AUD-MERO-18-32

Management Assistance Report: Improper Installation of Key Components of U.S. Embassy Kabul, Afghanistan's Fire Alarm System Needs Prompt Attention

Figure 1: Redundant Path Required by NFPA 72

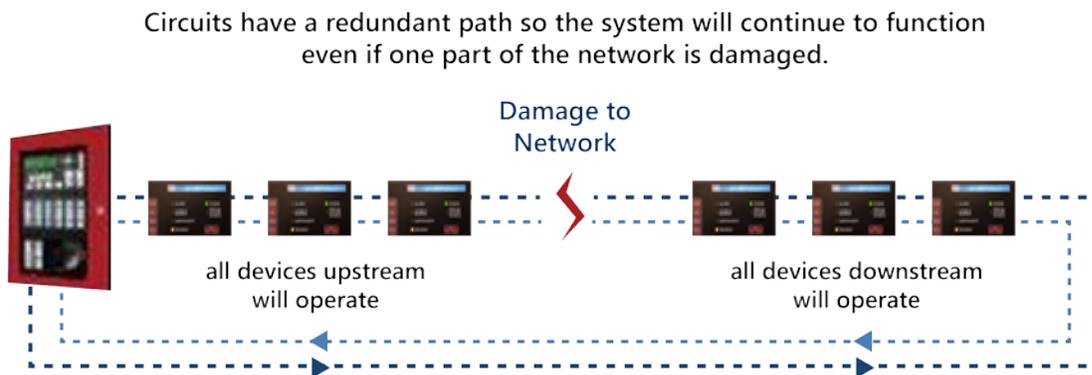
OIG found the pathways between fire alarm control panels at Embassy Kabul do not have a separate redundant path, as required by NFPA 72, to provide survivability in case of damage or failure to one part of the network. According to PAE, a secondary path was installed. However, rather than being routed separately, the existing fiber optic cables run in a parallel path. Because the fiber optic cables run in the same direction and are bundled together in the same conduit, damage to one part of the network can render sections of the network inoperable. This routing is contrary to NFPA 72 standards. OBO officials acknowledged that a redundant path has not been installed throughout the embassy compound but stated that, because the fiber optic cable network is part of a larger project involving the construction of multiple buildings and facilities, there is no requirement to install such a redundant path until the end of the entire construction project. OIG notes, however, that Caddell began construction on the embassy compound in 2011 and construction is not due to be completed until March 2019. In fact, many of the fire alarm control panels that would have been included in the redundant path are located in buildings that have been in use since 2011. As a result, OBO has postponed compliance with NFPA 72 standards for 8 years while the embassy is under construction. Further, OBO officials have acknowledged that additional proposed modifications to Caddell's contract could further delay completion of construction beyond March 2019.

As OIG explained in the original draft of this report, the diagram included in that draft did not represent the fiber optic network currently installed on the embassy compound. Rather, the diagram represented what a *proper* redundant path would have looked like had it been installed on the embassy compound, as required by NFPA 72. To avoid any potential confusion, however, OIG removed the diagram from the report. OIG made no further changes to the report on the basis of this comment.

NFPA 72 requires a redundant path for Class A circuits. Because it appears that the word "loop" is causing confusion, OIG replaced the word "loop" with the word "path" throughout the report. In addition, OIG added a diagram explaining the precise nature of its concerns. Regardless, as outlined below on page 25, the fiber optic cables currently in use at Embassy Kabul are bundled together in the same conduit, which is contrary to NFPA standards. As a result, any damage to one part of the network can render sections of the network inoperable. As OIG reported, OBO must address this condition.
